**Re: City of Coos Bay Land Use Application #187-18-000153  
Concurrent Land Use Applications by Jordan Cove Energy Project L.P.  
Coos Bay Estuary Navigation Reliability Improvements  
Comments of Oregon Shores Conservation Coalition – Rebuttal Evidence**

Document Title	Pages
Oregon Dep’t of Env’tl. Quality (“DEQ”), <u>Jordan Cove 401 Water Quality Certification Decision Cover Letter</u> , (May 6, 2019)	4
DEQ, <u>Evaluation and Findings Report: Section 401 Water Quality Certification for the Jordan Cove Energy Project</u> , (May 2019)	209
Oregon Shores, Second Open Record Period Comment for Coos County NRIs	12
Substantive Comments of Sarah Reif, ODFW on DSL Removal-Fill Permit Application No. 60697-RF, (Feb. 2, 2019)	45

Department of Environmental Quality

May 6, 2019

Figure 3: Schematic of Ridgetop Right-of-Way

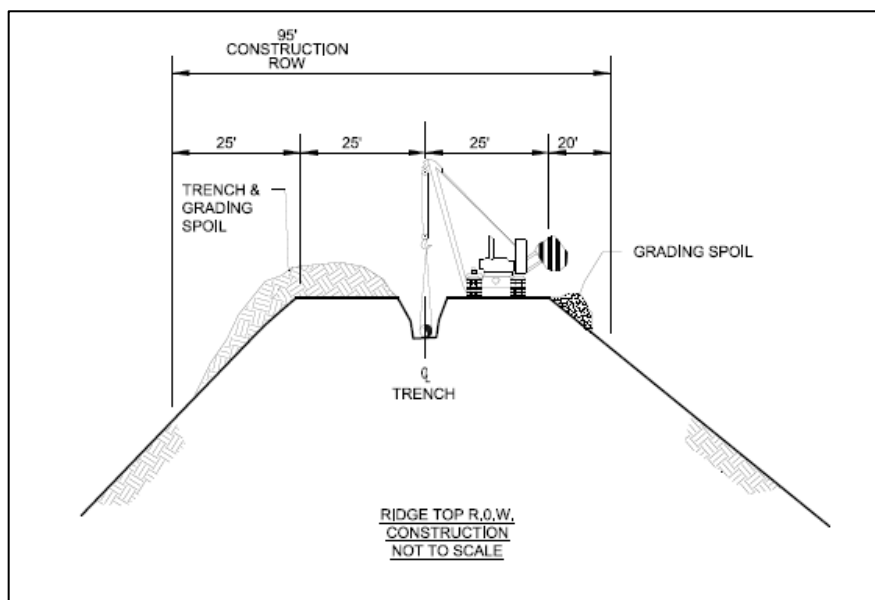
Although not delineated on JCEP's Environmental Alignment Sheets (Resource Report 1, Appendix H.1) or discussed in their Erosion Control and Revegetation Plan, typical drawings for right-of-way cross-sections in Resource Report 1 clearly show the use of a construction access road in the right-of-way. Without a durable surface, the soil in this corridor would experience compaction during the construction of the right-of-way, and during the trenching for pipe installation. The resulting soil compaction would increase runoff and, subsequently, erosion of native soils via rill and gully erosion without additional BMPs for the construction access road surface.

JCEP has not provided BMPs for the 229-mile construction access roadway in the form design standards, specifications, and measures necessary to support the anticipated traffic load.<sup>14</sup> For example, design standards would inform the construction of the road surface based on estimated traffic load. Design manuals are available that provide BMPs for a stabilized construction roadway where displacement of soil occurs due to vehicle traffic.<sup>15</sup>

Figure 5: Spoil Placement on Headwalls for Construction ROW and TEWA 8.72-W between MP 8.56 – 8.75

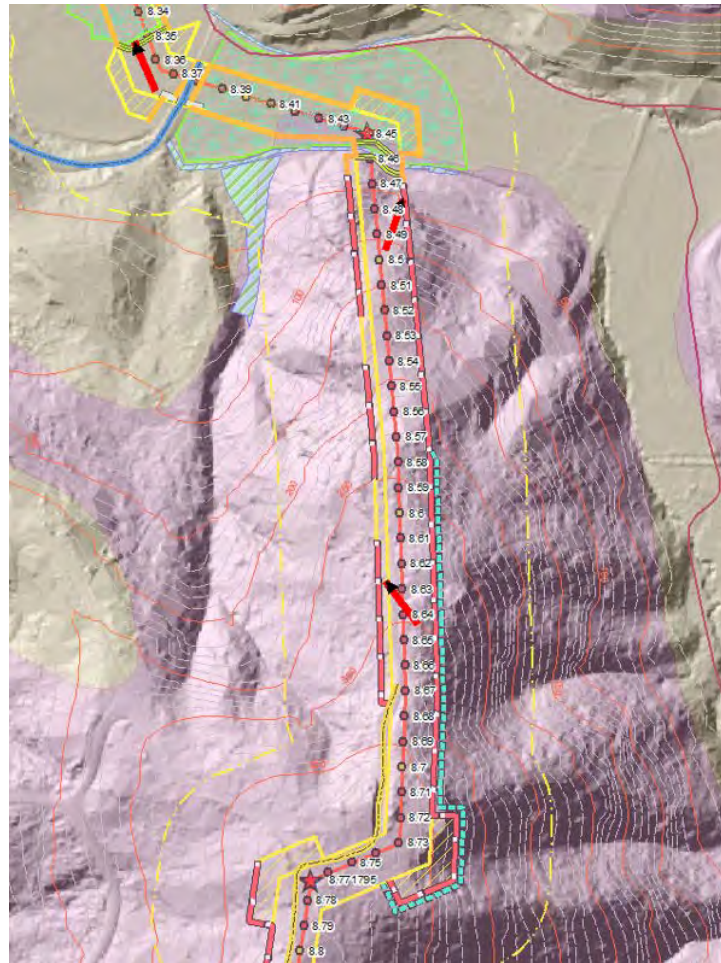
In the January 31, 2019 meeting to discuss the September 7, 2018 information request, JCEP presented a segment of the pipeline overlay on a Light Detection and Ranging Map (see Figure 5). This LiDAR map segment clearly shows the working side of the construction ROW with its construction access road and Temporary Extra Work Area above three headwalls (i.e., unstable slopes). As discussed above, these areas would support trenching and grading spoils and may require fill to level this working surface. The weight of the fill and/or trench and grading spoils, the anticipated traffic loads, and the stored material in combination with additional runoff due to the lack of a forest canopy present a substantial water quality risk to streams as well as a risk to worker and public safety.

Given the proposed placement of trench and grading spoils and, potentially, fill placed on the rapidly moving landslide risk area from Pipeline Milepost 8.56 to 8.75 (see Figure 5), DEQ reviewed Table B-3a in Resource Report 6 as a quality assurance check on JCEP's Phase I landslide hazard evaluation. Table B-3a summarizes the sites investigated in JCEP's Phase II field reconnaissance. In its review of this table, DEQ determined that JCEP did not include the area from between Milepost 8.56 to 8.75 in its field data collection and risk assessment. JCEP also did not conduct a surface reconnaissance for the areas of concern featured in Figures 6 and 7. Given this, DEQ referenced the methodology for identifying moderate and high rapidly moving landslide (RML) risks in Resource Report 6 as described below.

Figure 6: Fill Placement on Headwalls for Construction Right-of-Way and TEWA 10.71-W MP 10.78 – 10.87

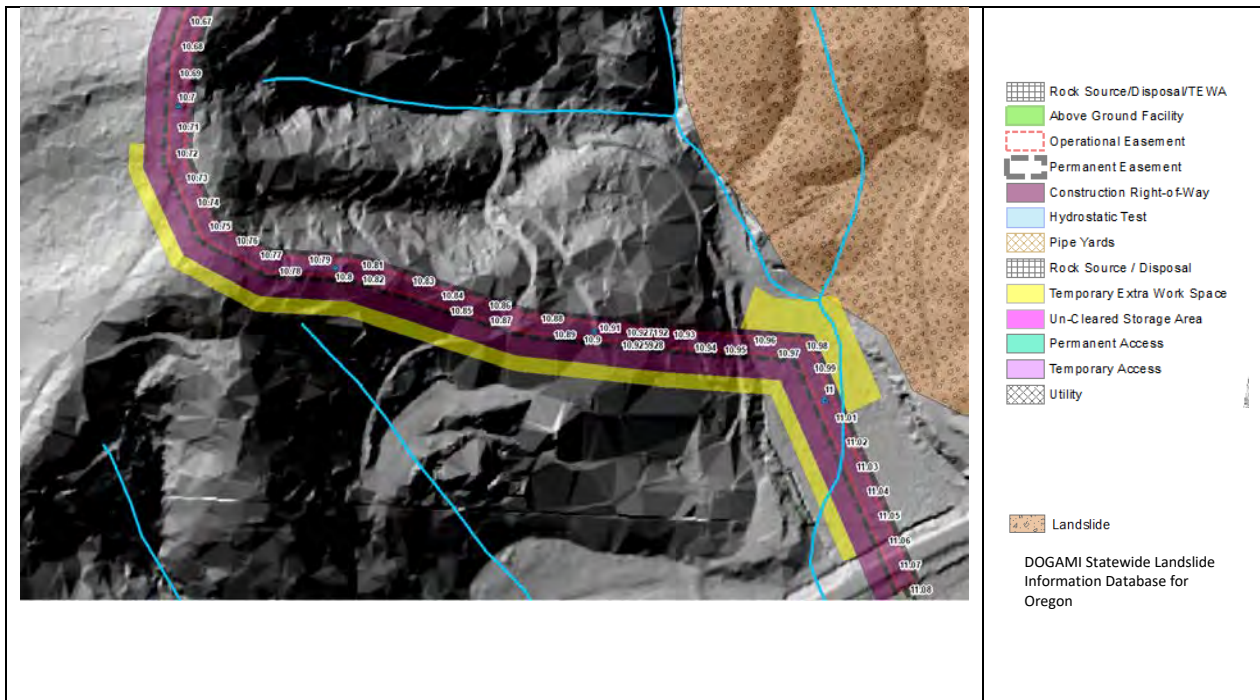
On Page 31 in Section 4.5.3.2 of Resource Report 5 (Geologic Resources), JCEP indicates it used LiDAR, 10-meter DEM, and aerial photography to identify moderate and high RML sites. This section provides the risk criteria JCEP used to identify the RML sites selected for surface reconnaissance and included in Table B-3a. JCEP's selection criteria was to identify the potential for a RML to induce strain on the pipeline and for RML erosion to expose a pipeline. These two selection criteria would not ensure the identification of RML sites posing a risk to streams and water quality. The above quality assurance check confirmed DEQ's concerns presented in the December 20, 2018 information request that JCEP's landslide hazard evaluation did not consider the landslide hazard risks to streams initiated by the construction and operational ROW.

Figure 8: Map of Hudson Creek-North Fork Coquille Subwatershed

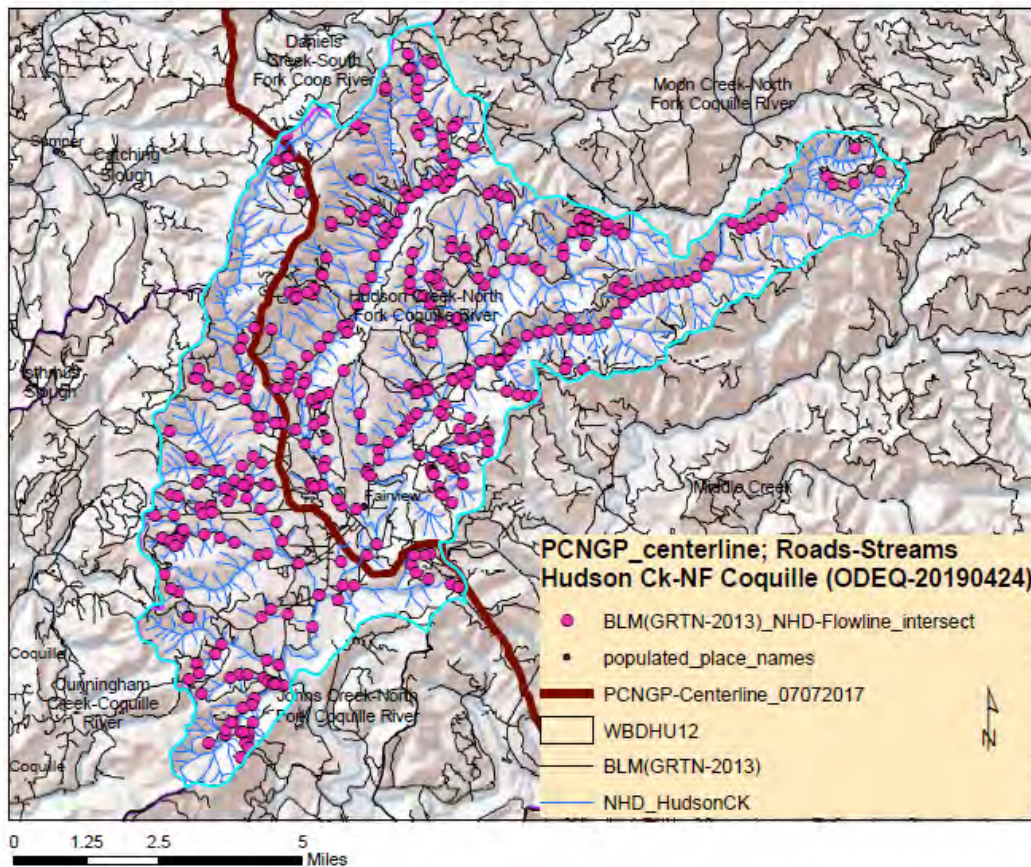
As a sample of road-stream intersections in the highly dissected drainage basins of the Coast and Cascade Ranges, Figure 8 shows the number of BLM road-stream crossings in just one of numerous subwatersheds where the construction ROW is located. This map does not include cross drains for roads that are also within 200 feet of a stream and, therefore, hydrologically connected to this stream. If a field inventory included cross drains, the number of road-stream interactions on this map would be greater than currently displayed in Figure 8. Many of the BLM roads depicted in the map below would serve as an existing access road for pipeline construction. Given this small area, JCEP's estimate of 21 existing access roads that could potentially deliver sediment is a significant underestimation.

Figure 9: Construction Right-of-Way Above Headwall

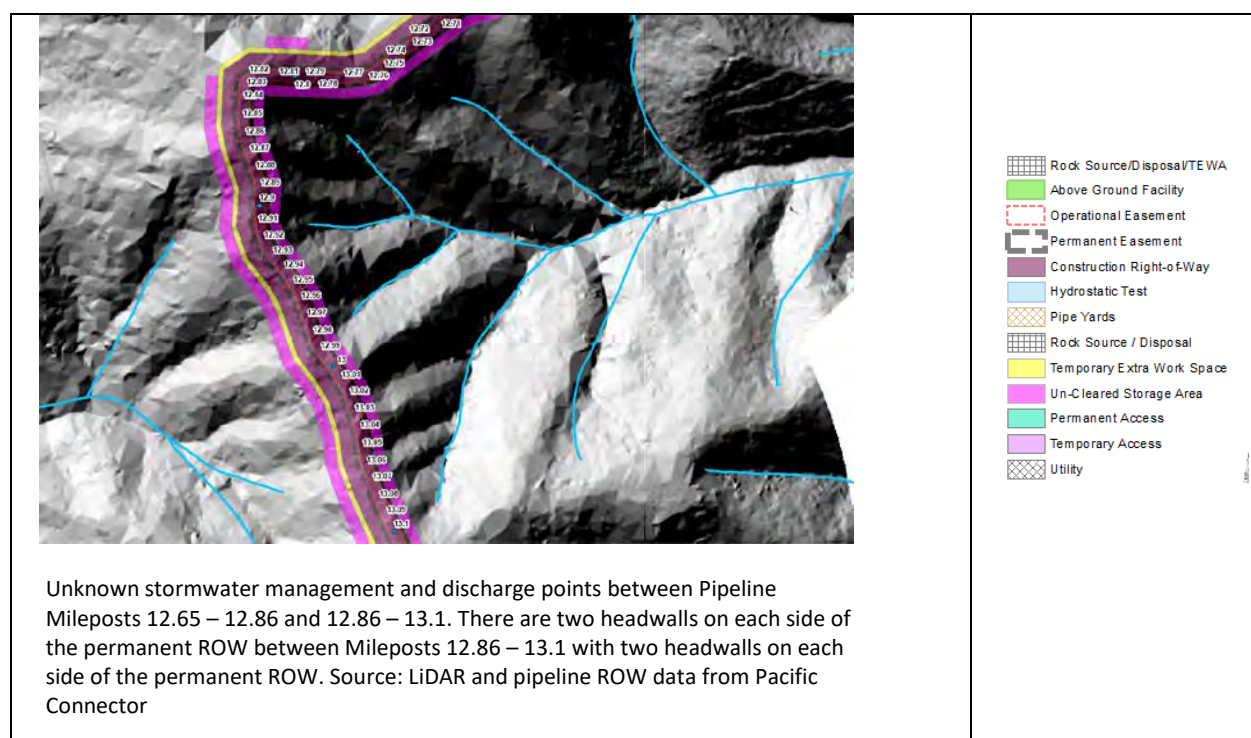
To ensure compliance with statewide narrative criteria OAR 340-041-0007(1), DEQ developed the *Section 401 Water Quality Certification Post-Construction Stormwater Management Plan Submission Guidelines* (March 2018). In Section E.2.2 of these plan submission guidelines, DEQ requests that project proponents determine if infiltration of stormwater discharge should be avoided due to steep slopes or landslide risks (see Page 9). The proposed permanent ROW traverses over and along unstable slopes in numerous locations. For example, Figure 9 below shows sections of the permanent ROW above headwalls. JCEP has not provided DEQ with a post-construction stormwater plan for the permanent ROW demonstrating how JCEP would manage stormwater along the permanent ROW and, in particular, along landslide susceptibility zones. As discussed in Section 6.1.2.1 of this Evaluation and Findings Report, the stormwater discharge from slope breakers can reduce slope stability.

Figure 10: Pipeline Parallel to and Crossing Spencer Creek and crossing Clover Creek, near Milepost 177

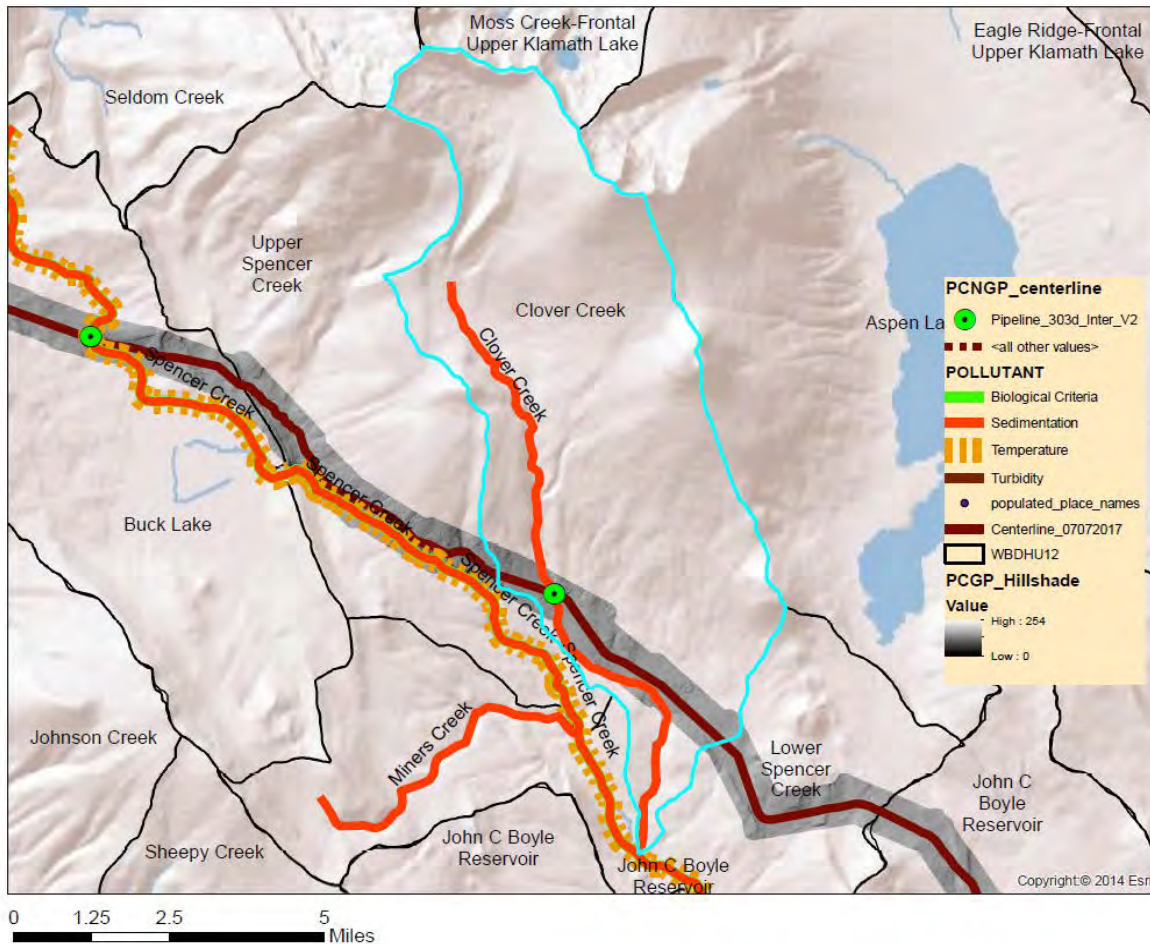
Figure 10 shows one of several examples of the permanent ROW crossing or paralleling streams on the 303(d) list for sediment or crossing streams discharging to these sediment-listed streams. Based on its proposed conceptual approach for operating the ROW, the permanent ROW has the potential to discharge sediment at stream crossings. Ongoing increases in sediment loading to a waterbody that is listed on the 303(d) list for sediment is not allowed without either a TMDL allocation, or an implementation plan showing that there will be no increase in loading. OAR 340-41-0004(7) (“Water quality limited waters may not be further degraded except in accordance with paragraphs (9)(a)(B), (C) and (D) of this rule.”)<sup>65</sup> JCEP has not provided the analyses for the discharges that would

For example, given the proposed pipeline route, Figure 10 shows the potential for the loss of effective shade from the construction right-of-way as the pipeline parallels Spencer Creek near Milepost 177. Spencer Creek is listed as impaired for temperature. JCEP informed DEQ that the riparian impacts from TEWAs and impacts from FERC's 15-foot buffer requirement, noted above, were not included in the 2017 Thermal Impact Assessment. DEQ requested that JCEP include these impacts in a revised assessment. To-date, JCEP has not provided this revision.

Figure 10 shows the potential for the loss of effective shade from the permanent right-of-way as the pipeline parallels Spencer Creek near Milepost 177. DEQ listed Spencer Creek as impaired for temperature. JCEP informed DEQ that the riparian impacts from FERC's 15-foot buffer requirement, noted above, were not included in the 2017 Thermal Impact Assessment. DEQ requested that JCEP include these impacts in their assessment and provide a revised assessment.

Figure 11: Potential Dredge Disposal Areas Relative to LNG Terminal and Adjacent Wetlands

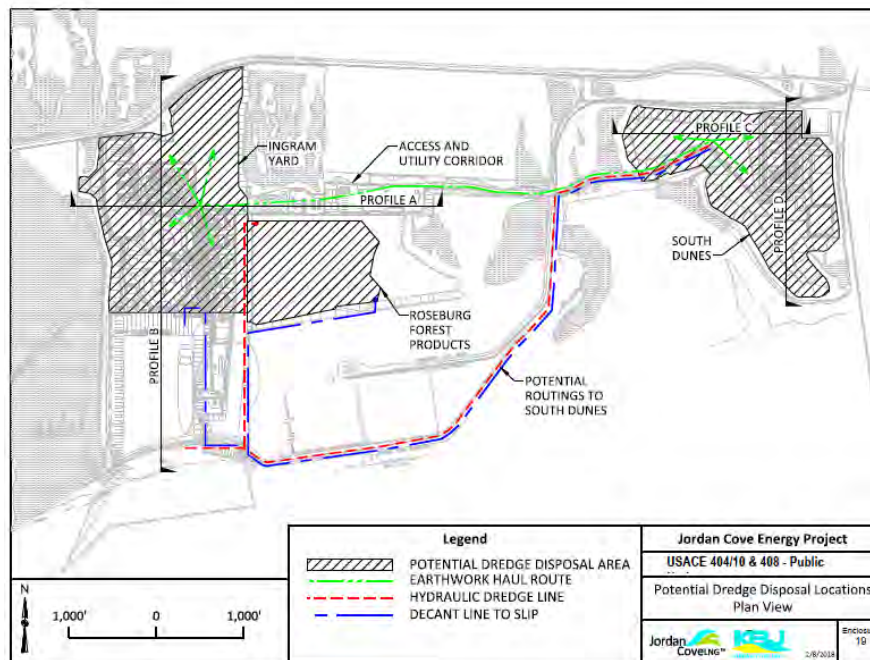
In its October 8, 2018 response to DEQ's September 7, 2018 information request, JCEP referred DEQ to Potential Dredge Disposal Locations featured in Enclosures 19 – 22 of Part 1, Appendix N-5 of the 401 Water Quality Package. DEQ presents Enclosure 19 below to highlight the lack of detailed practices to manage the wetlands – shaded gray – adjacent to proposed dredging disposal areas:

Enclosure 19 does not show structural controls to demonstrate saline leachate or decant from dredged material would not discharge to adjacent freshwater wetlands. JCEP has not indicated how it would place containment

Figure 12: Proposed Finish Grade of Dredge Soil Locations

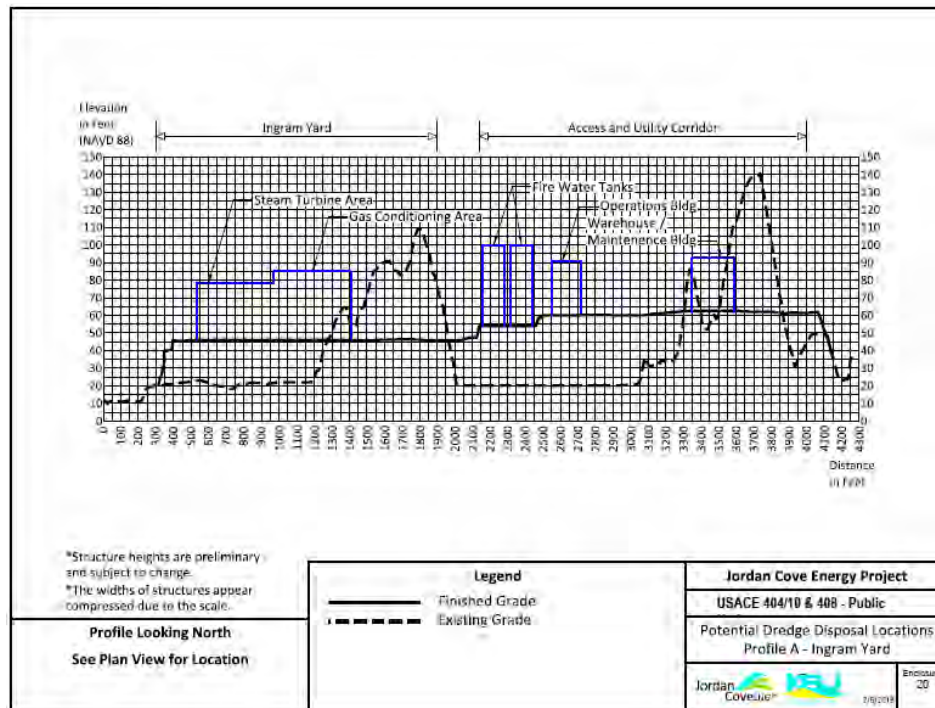
structures around the dredged material nor change the grade to direct decant to the dredge line, size a collection basin to capture the decant, operate a pump to transfer the decant to a discharge location, or propose a discharge location. Enclosures 20 – 22 only provide the elevation of dredge material as shown in Figure 12.

Figure 13: Lick Creek and Little Butte Creek Vicinity

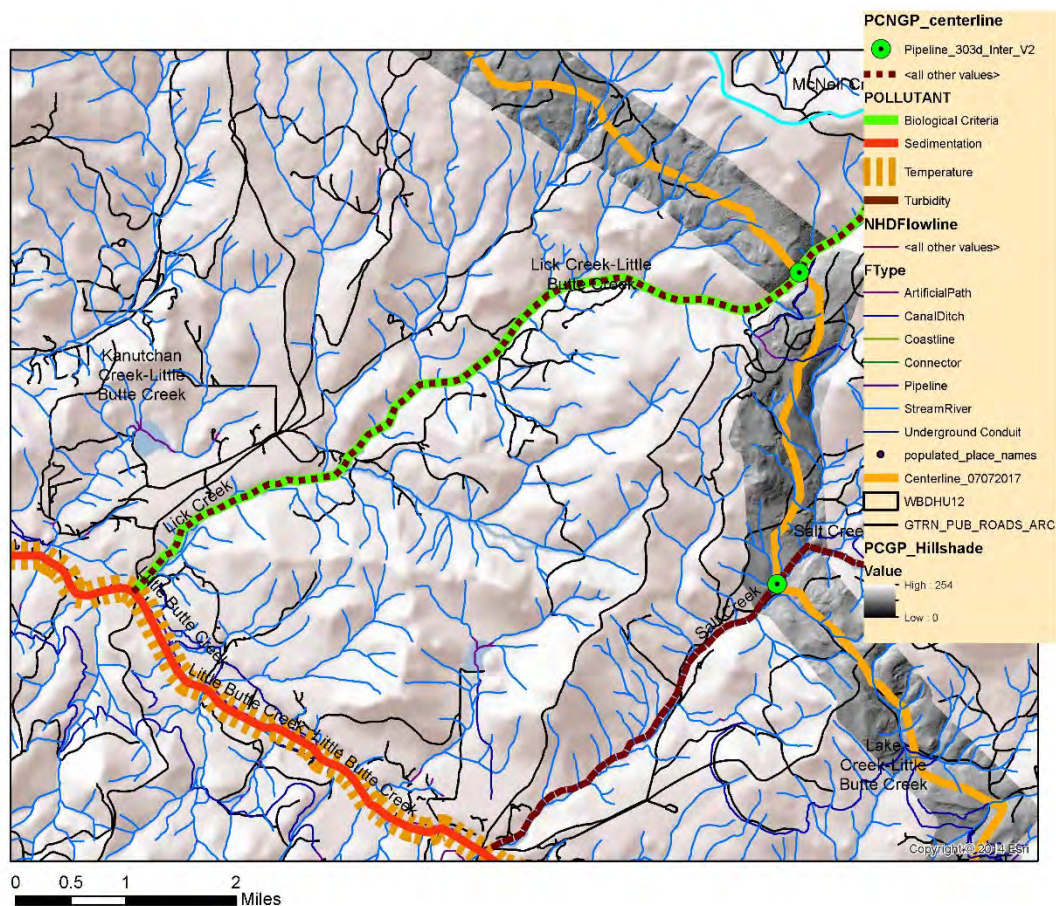
Figure 13 shows the JCEP Gas Pipeline crossing tributaries to Lick Creek and crossing Lick Creek near Milepost 140.27. Lick Creek is listed on the 303(d) List for biocriteria. Sediment discharge from pipeline construction and debris flows from landslides initiated by the construction of the right-of-way could affect aquatic life in Lick Creek and the attainment of the biocriteria standard in this impaired waterbody. As noted earlier in this report, for a 303(d) listed waterbody, without a TMDL, no ongoing detrimental impact is authorized. Although natural landslides are an integral part of stream form and function, human-caused debris torrents and sedimentation impact water quality by changing the natural cycles of sediment delivery to systems, which impacts the aquatic environment; thus, affecting aquatic life (Castro and Reckendorf 1995).

Figure 15: Pipeline Crossing at Wetland S1-04 (Willanch Slough) showing no “neckdown” of the ROW

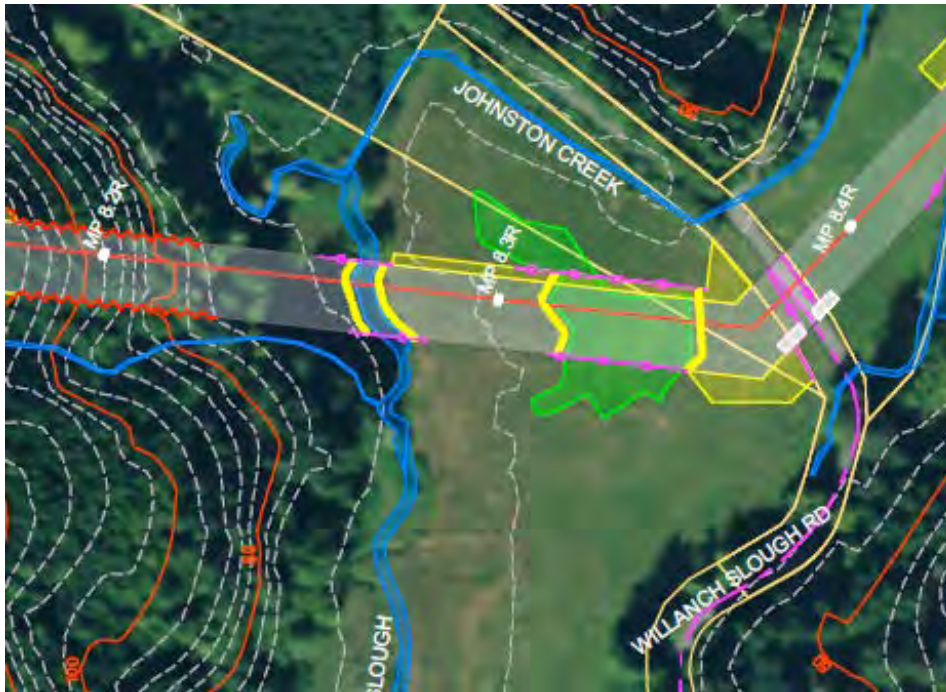
As an illustration of the reasons for DEQ's concerns about the temperature impacts of the proposed Project, at pipeline stream crossing at Milepost 58.78, Ollala Creek is limited for temperature year round and is under an approved TMDL. Similarly, DEQ has placed Rice Creek (Milepost 65.76), South Umpqua River (Milepost 71.27), North Myrtle Creek (Milepost 79.12), South Myrtle Creek (Milepost 81.19), and many others on the 303(d) list for temperature. These streams are under an approved temperature TMDL.
